DATE: 4/10/2018	JOB NO. 1808
ATTENTION: Planning Board	
RE: Site Plan Approval	
36-64 Maplewood

RE: Application for Site Plan Review for 46 – 64 Maplewood Avenue, Portsmouth Tax Map 154 – Lot 2

On behalf of 30 Maplewood, LLC, we hereby submit Site Plans for the 46 - 64 Maplewood Avenue project for Planning Board approval. The applicant has worked to address comments throughout the process. We submitted revised plans and supporting material on February 6th to address the Technical Advisory Committee Site Plan Conditions of Approval from their January 30, 2018 meeting. The plan set has also been revised to address the Stipulations and Conditions proposed from the February 15 Staff memo. The Planning Board, at your meeting on March 15, 2018, voted to table the application to your April meeting to address the following:

SCALE: 1" = 10' JUNE 2017**GRADING AND DRAINAGE PLAN****C6**

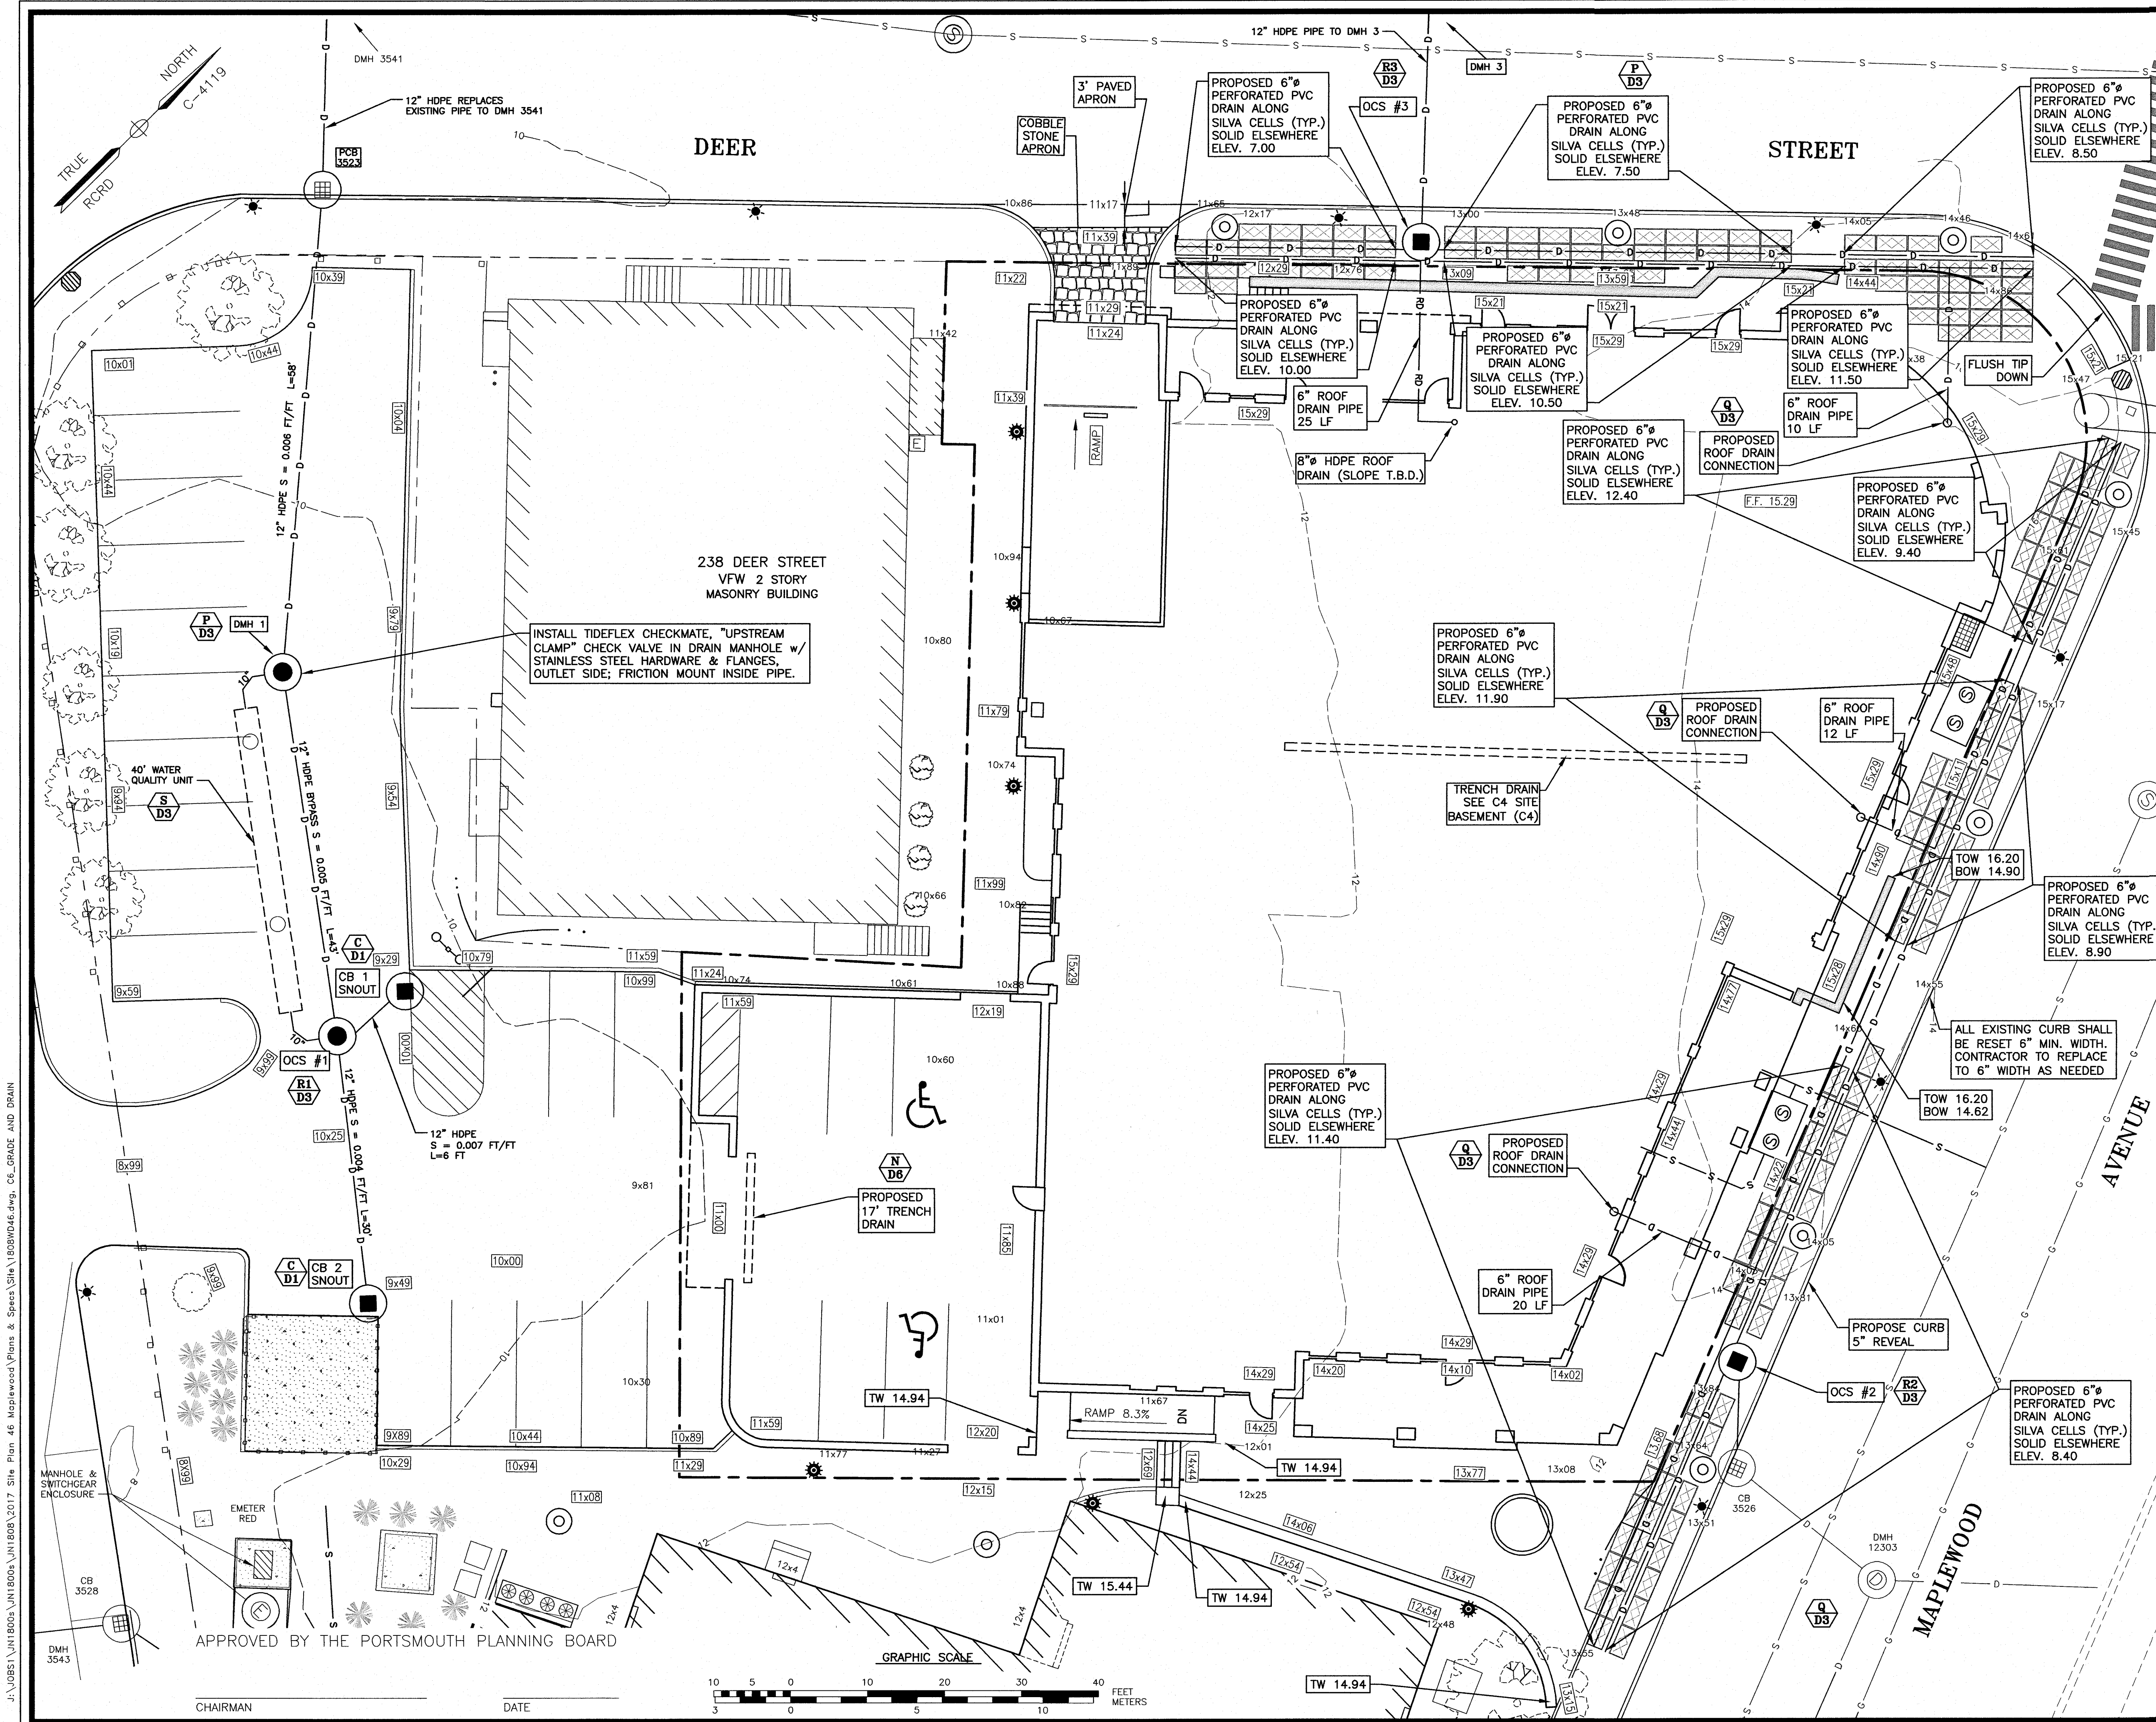
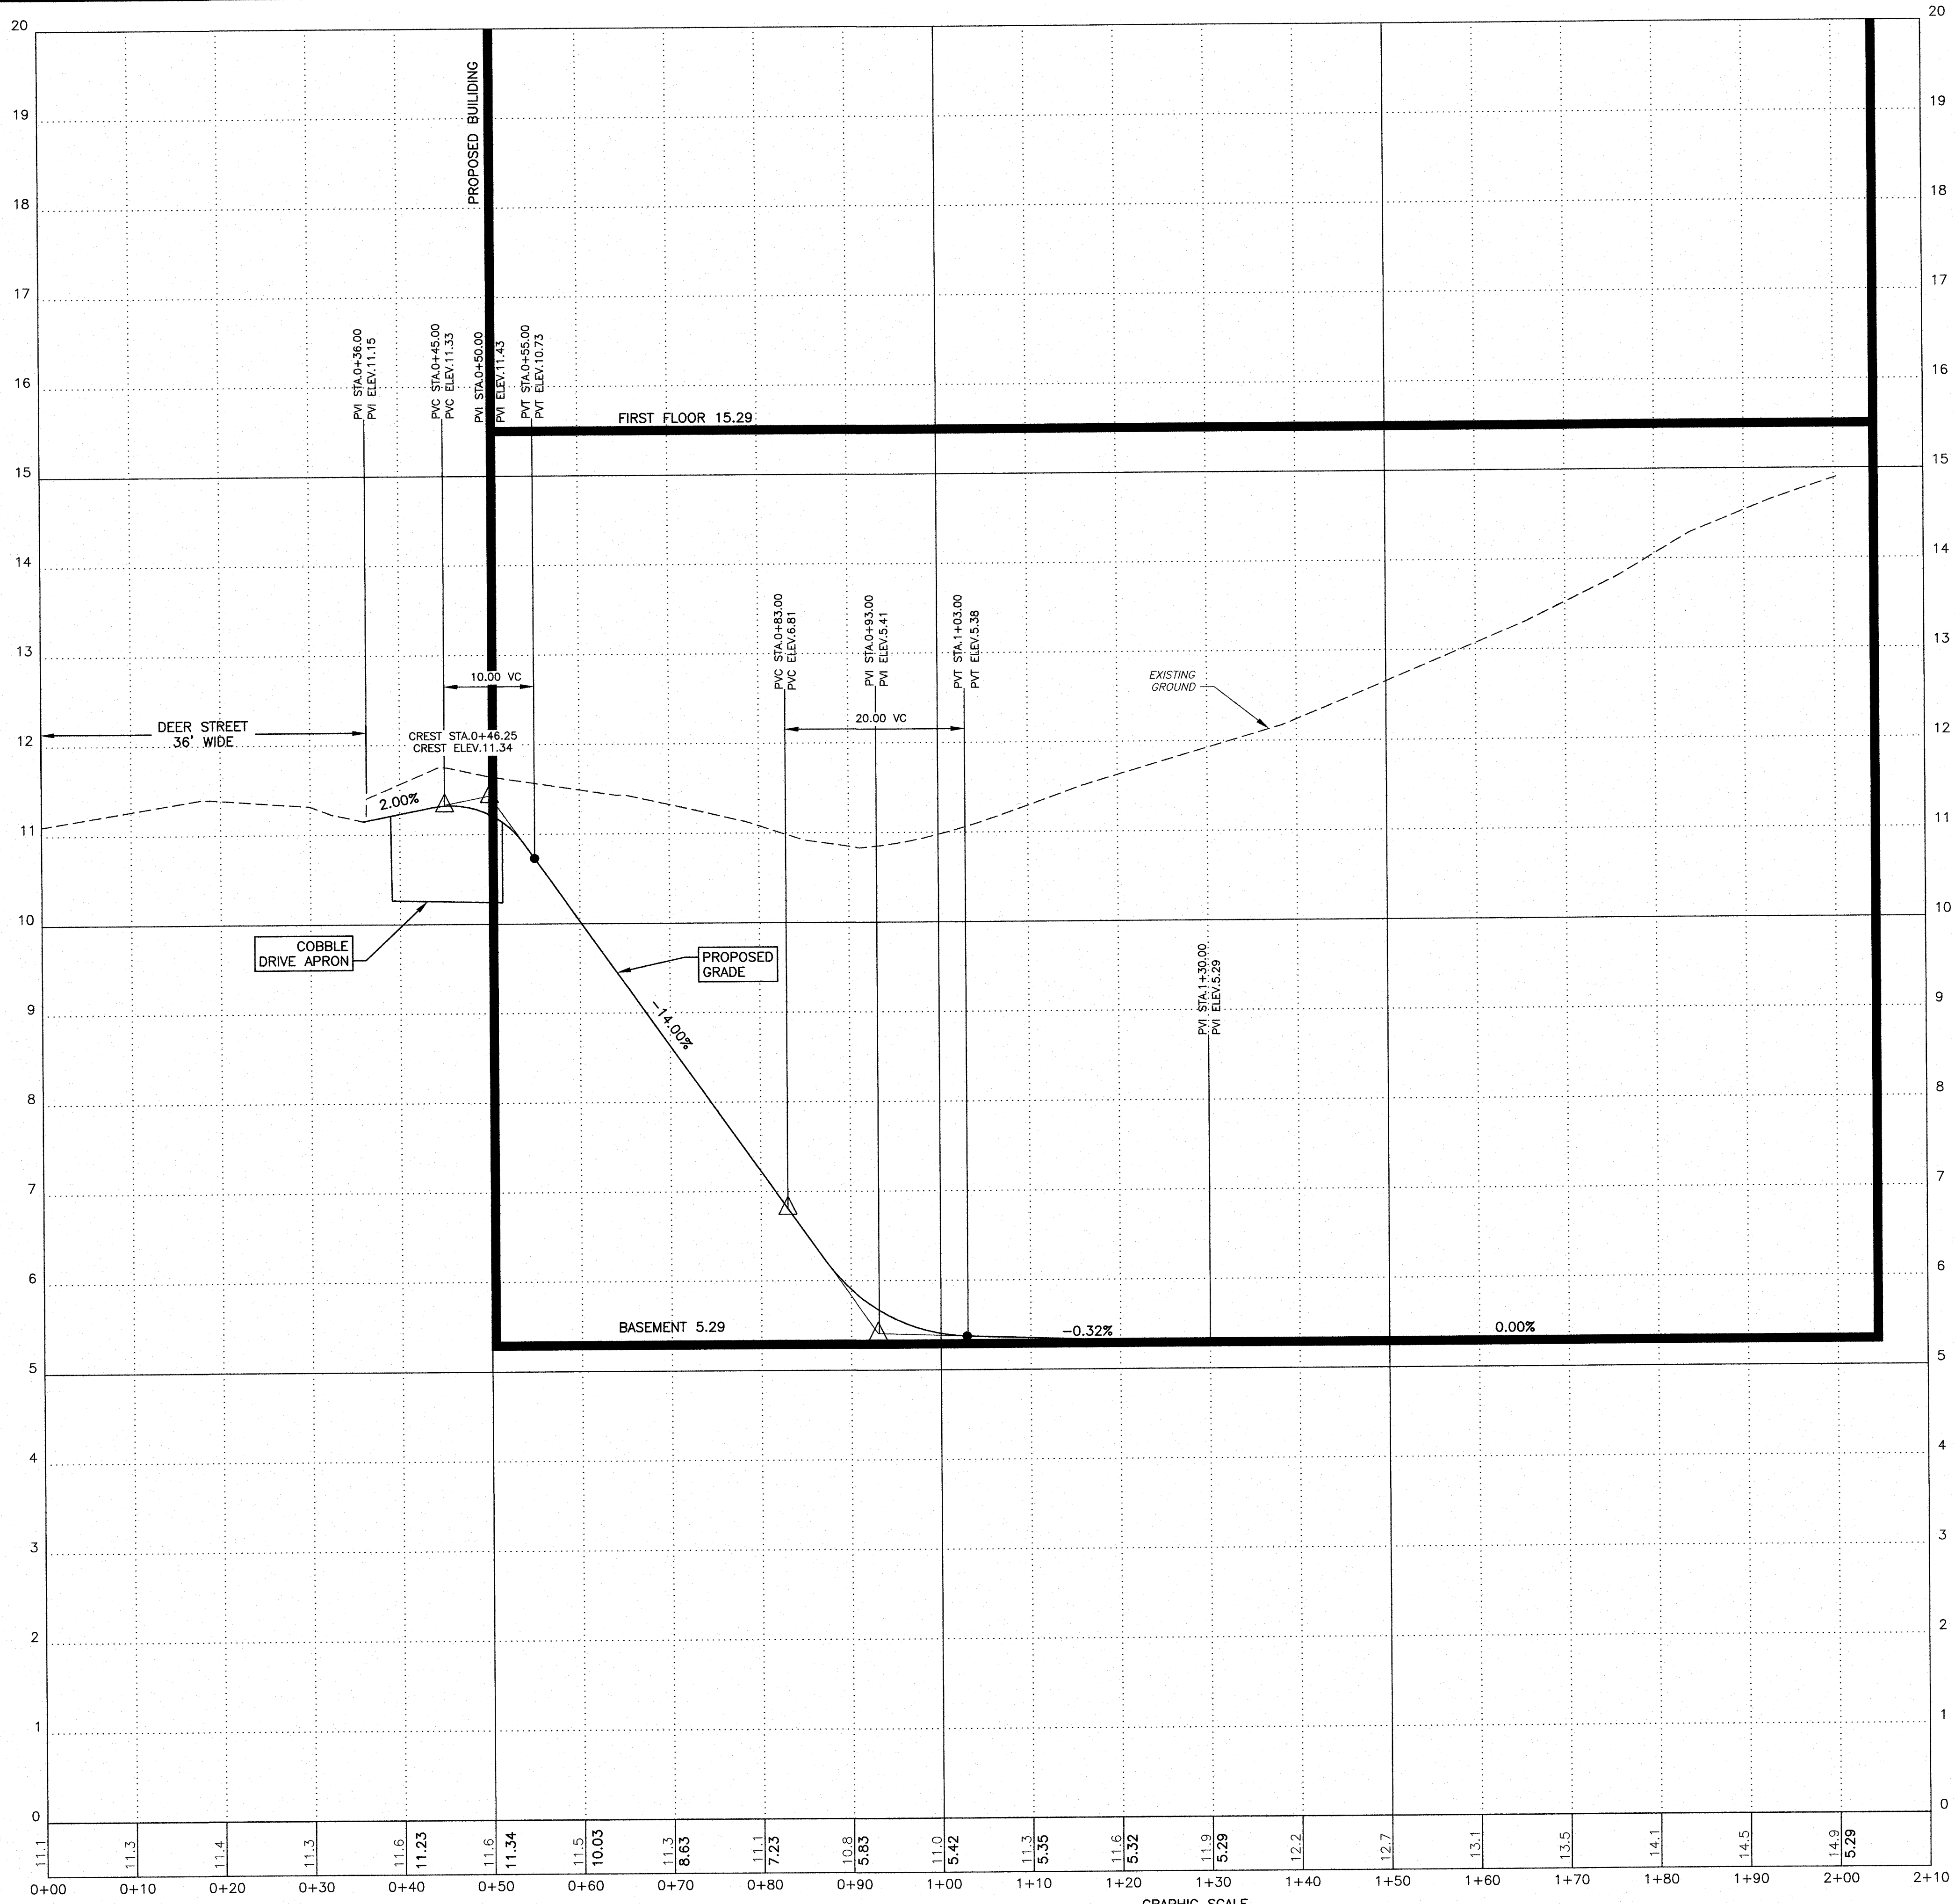
4. Temporary Dewatering will be allowed with a permit. Building ground water dewatering with underdrains will not be allowed. Revise Note 5 on Sheet C6 to reflect this requirement. **Note 5 on Sheet C6 has been revised to reflect similar language approved by the City for the DSA Deer Street project. While we understand there is a capacity issues an outright prohibition is not fair to the applicant. As a part of the approval the City is requiring a contribution from the applicant for a Drainage Analysis of the existing drainage system. The applicant has engaged a Geo-technical Engineer who prepared a report (attached) indicating the level of groundwater discharge to be 1,000 – 1,500 gallons per day. This is an insignificant amount compared to the upstream watershed. It would be prudent to wait for the results from the study to see what capacity may exist, and hope the City could include the applicant's report in the analysis to gauge impact.**
